**From:** Lemont, Stephen  
**Sent:** Monday, November 30, 2015 9:39 AM  
**To:** 'Cherry, Robert N CIV USARMY IMCOM HQ (US)'  
**Cc:** skibinskij@leidos.com; James Prikryl; aminor@swri.org; Pat LaPlante (plaplante@swri.org); gwalter@swri.org  
**Subject:** NRC Questions and Clarification Requests on Army's 10-1-15 JPG EIS RAI Responses and Related Matters  
**Attachments:** NRC QUESTIONS AND CLARIFICATION REQUESTS ON ARMY'S RAI RESPONSES FOR JPG DU IMPACT AREA EIS, NOV. 30, 2015.pdf

**NRC QUESTIONS AND CLARIFICATION REQUESTS ON  
U.S. ARMY'S REQUEST FOR ADDITIONAL INFORMATION RESPONSES  
FOR JEFFERSON PROVING GROUND DEPLETED URANIUM IMPACT AREA  
ENVIRONMENTAL IMPACT STATEMENT  
NOVEMBER 30, 2015**

Figure 6-2 (U.S. Army, 2013)  
Figure 5-2 (SEG, 1996)  
Figure 5-1 (SEG, 1995)  
Figure 3-5 (SEG, 1996)

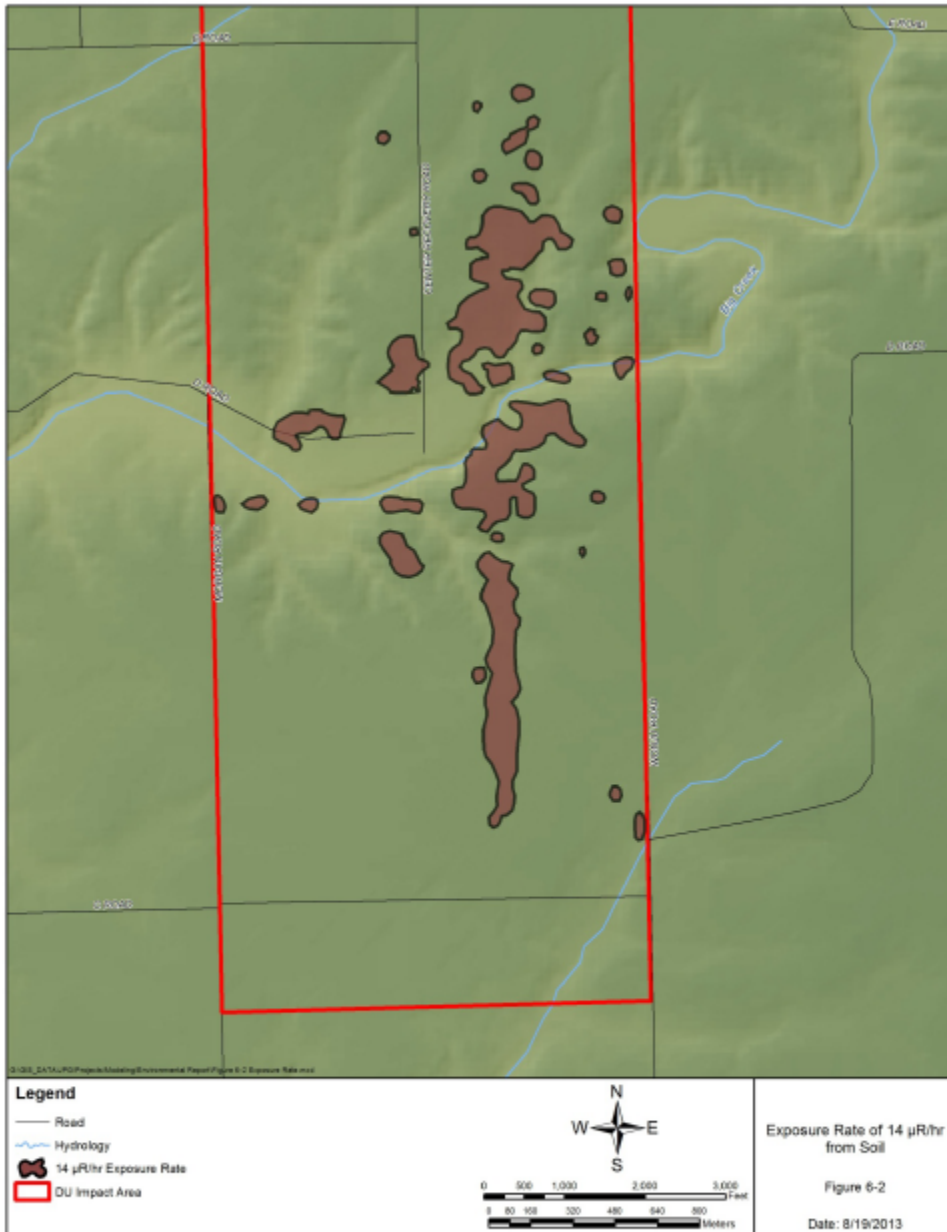
***ER FIGURE 6-2, “EXPOSURE RATE OF 14  $\mu$ R/hr FROM SOIL”***

NRC staff could not locate the information presented and described in ER Figure 6-2 in the cited Scientific Ecology Group, Inc. (SEG) reference document, “*Jefferson Proving Ground Depleted Uranium Impact Area: Characterization Survey Report*” (SEG, 1996). **Review the caption and reference for Figure 6-2 in the ER (U.S. Army, 2013) and provide any necessary corrections or clarifications to ensure the data being presented in the figure match the caption and the cited reference.**

Based on NRC staff’s review of available Army site characterization information for the DU Impact Area, staff believe that ER Figure 6-2 may be showing the gamma exposure rate measurements within the DU Impact Area which exceed the 95 percent confidence interval about the mean of all gamma exposure rate measurements rather than the areas corresponding to a DU concentration of 35 picocuries/gram (pCi/g) as stated in Section 6.1.1.2 on page 6-6 of the ER (U.S. Army, 2013). NRC staff consider the “95 percent confidence interval” information to be useful for broadly describing the areas within the DU Impact Area that have elevated concentrations of DU, but need a clearer understanding of information that is being presented in ER Figure 6-2 as well as the origin of that figure. The following paragraphs provide additional details.

The Army’s cited source for ER Figure 6-2, “Exposure Rate of 14  $\mu$ R/hr from Soil” (see attached below), is SEG (1996). Section 6.1.1.2 on page 6-6 of the ER text describes what is presented in the figure as follows: “*The exposure rate corresponding to a DU concentration of 35 pCi/g is 14.4 microRoentgens per hour ( $\mu$ R/hr). The contour map showing areas with an exposure rate greater than 14.4  $\mu$ R/hr is shown in Figure 6-2.*” (emphasis added). The closest match that NRC staff located in the cited source document (SEG, 1996) for the above is Figure 5-2 (see also attached below). SEG (1996) Figure 5-2 appears to be conveying the same information according to the figure caption (Figure 5-2, “Affected Area at 35 pCi/gm (14.4  $\mu$ R/hr”); however, the marked “affected area” contours on Figure 5-2 are noticeably smaller than those depicted in ER Figure 6-2. The text of Section 5.1 on page 5-2 in SEG (1996) states: “*The exposure rate corresponding to a DU concentration of 35 pCi/g is 14.4  $\mu$ R/hr. This value is programmed into the mapping software, to define a new affected area. The resulting affected area contour map based on the exposure rate is shown in Figure 5-2.*” Thus, the captions and descriptions on ER Figure 6-2 and SEG (1996) Figure 5-2 are consistent, but the depicted graphics are different.

Figure 5-1

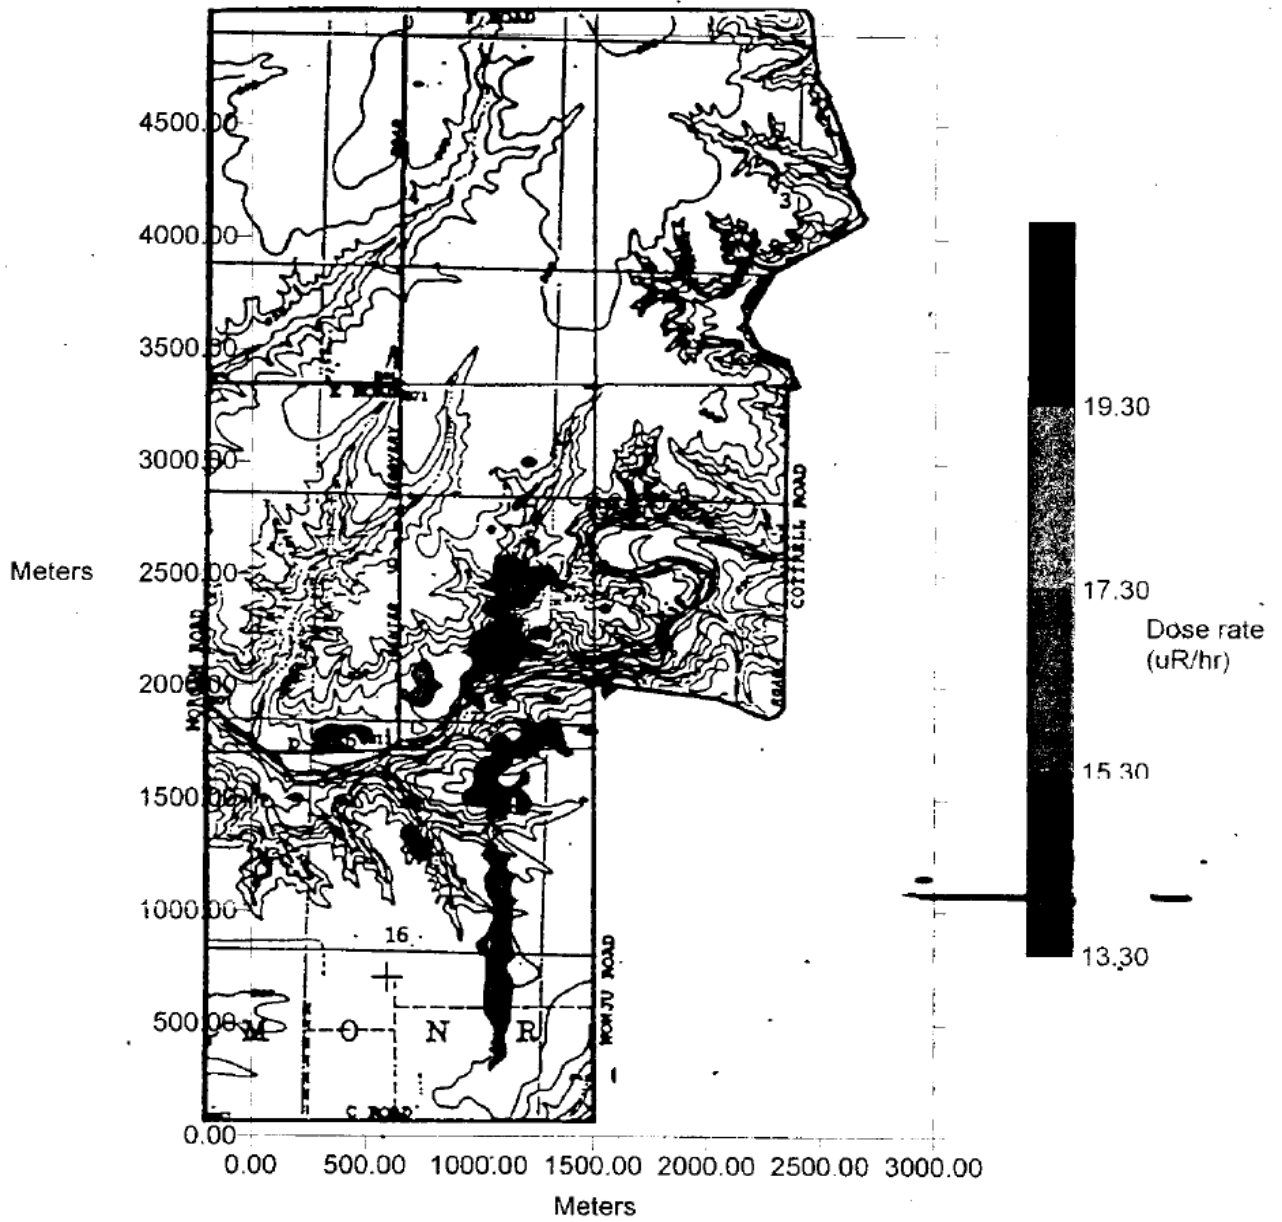
Further evaluation by NRC staff resulted in locating Figure 5-1 (see also attached below) in the “*Jefferson Proving Ground Depleted Uranium Impact Area: Scoping Report*” (SEG, 1995). This figure illustrates information that matches the elevated gamma exposure contours shown in ER Figure 6-2 (i.e., the same or very similar data are presented). The caption of Figure 5-1 in SEG (1995) is “*Impact area with dose rates greater than or equal to 13.3  $\mu$ R/hr*” (emphasis added). The text of Section 5.0 on page 5-2 of the SEG (1995) report describes Figure 5-1 as follows: “*...the radiation contour map for the 95% confidence level upper bound is shown in Figure 5-1. The areas shown are considered to be affected areas for the JPG firing range.*” The contours presented in SEG (1995), Figure 5-1 are those radiation measurements that were

Figure 3-5  
Random Soil Sample Locations  
(Sample taken at center of 50 meter Square Grid)

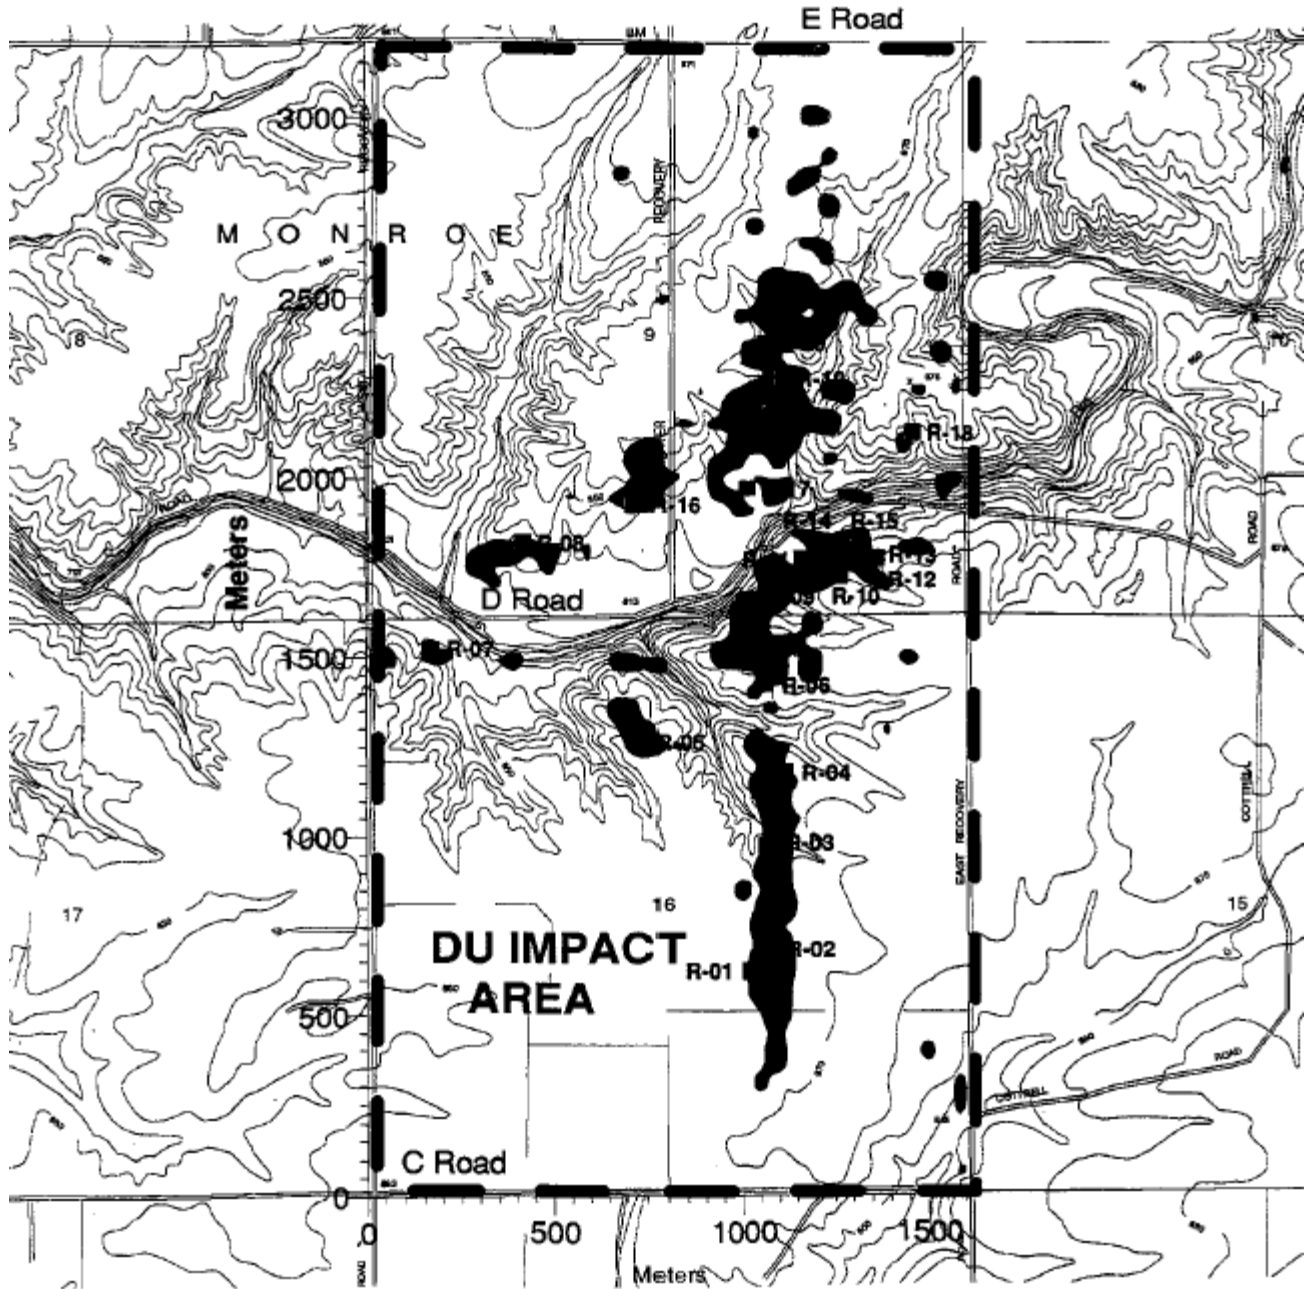
at or beyond the upper bound of the 95% confidence interval about the mean of all 25,098 gamma measurements in the DU Impact Area. Additionally, the SEG (1996) report shows what appear to be the same contours depicted on a clearer graphic, Figure 3-5 (see also attached below); however, Figure 3-5 is used to show soil sampling locations and the text of SEG (1996) does not specifically describe the contour information in that graphic. In summary, the contours of both figures SEG (1995) Figure 5-1 and SEG (1996) Figure 3-5 appear to match the contour data depicted in ER Figure 6-2 but not that figure's caption.
